DEVELOPMENT APPLICATION ASSESSMENT REPORT

Application Number:	DA2020/0107
----------------------------	-------------

Responsible Officer:	Thomas Prosser
Land to be developed (Address):	Lot 2 DP 16692, 103 Narrabeen Park Parade MONA VALE NSW 2103
Proposed Development:	Alterations and additions to a dwelling house
Zoning:	E4 Environmental Living
Development Permissible:	Yes
Existing Use Rights:	No
Consent Authority:	Northern Beaches Council
Delegation Level:	NBLPP
Land and Environment Court Action:	No
Owner:	Robert Stephen Nichols Selina Gioia Buresti
Applicant:	Selina Nichols

Figure 1: Montage provided by applicant showing the impact on views and vistas from one angle.

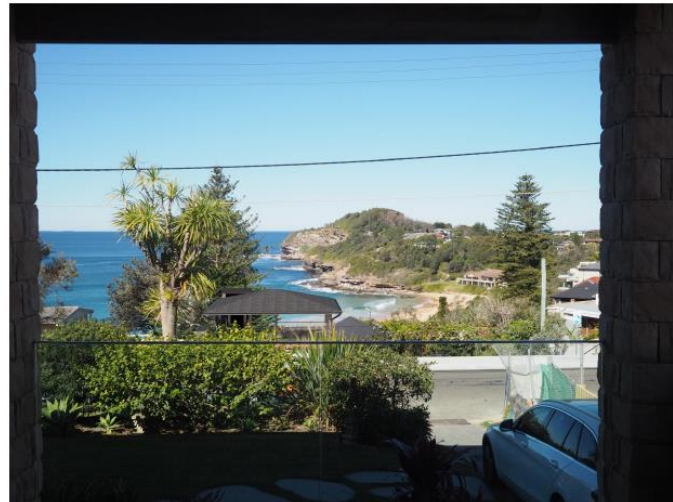
The proposed pitched roof carport will substantially obscure the view of Warriewood Beach from No.158. This involves obscuring of the beach (sand-water interface) by the structure as well as obscuring parts of the water and land. Given the intact nature of the existing view, this impact is assessed as being **moderate** to **severe**.

The proposal does not comply with the controls for front building line, building envelope or landscaped area (to the frontage) under the Pittwater 21 DCP. Furthermore, there is the opportunity of modifying the design from a pitched roof (which has greater roof bulk) to a flat roof (which has less roof bulk) and result in substantial improvement to the view sharing. As such, the moderate to severe impact on views caused by the taller and bulkier pitched roof structure is unreasonable.

Note: Further information would be required to determine if a flat roof is acceptable
